Fred Dong – Canyon Hills EIR Comments

Section IV. A GEOLOGY AND SOILS

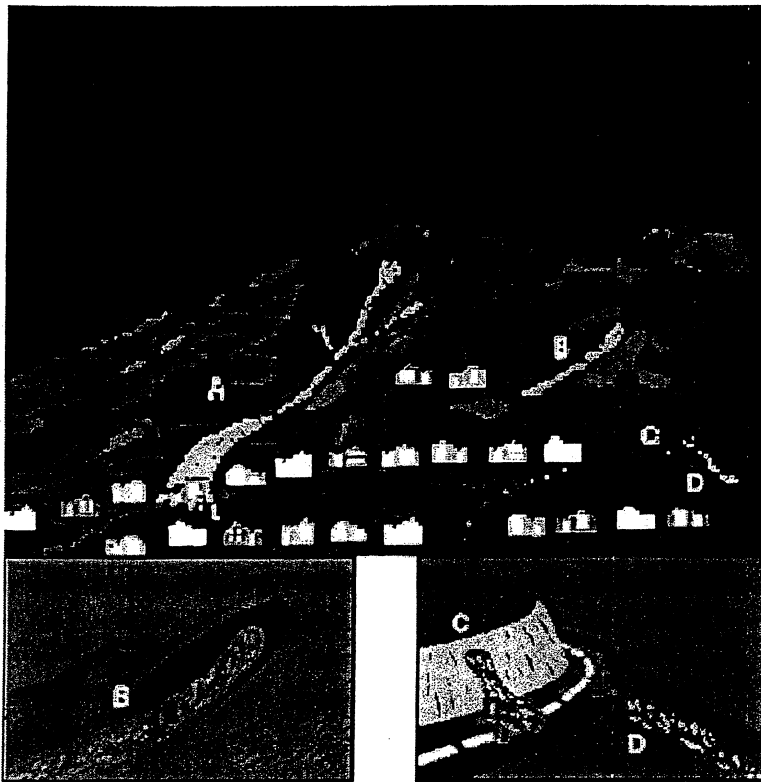
Debris flows start on steep slopes-slopes steep enough to make walking difficult. Once started, however, debris flows can travel even over gently sloping ground. The most hazardous areas are canyon bottoms, stream channels, areas near the outlets of canyons, and slopes excavated for buildings and roads.

A: Canyon bottoms, stream channels, and areas near the outlets of canyons or channels are particularly hazardous. Multiple debris flows that start high in canyons commonly funnel into channels. There, they merge, gain volume, and travel long distances from their sources.

B: Debris flows commonly begin in swales (depressions) on steep slopes, making areas downslope from swales particularly hazardous.

C: Roadcuts and other altered or excavated areas of slopes are particularly susceptible to debris flows. Debris flows and other landslides onto roadways are common during rainstorms, and often occur during milder rainfall conditions than those needed for debris flows on natural slopes.

D: Areas where surface runoff is channeled, such as along roadways and below culverts, are common sites of debris flows and other landslides.
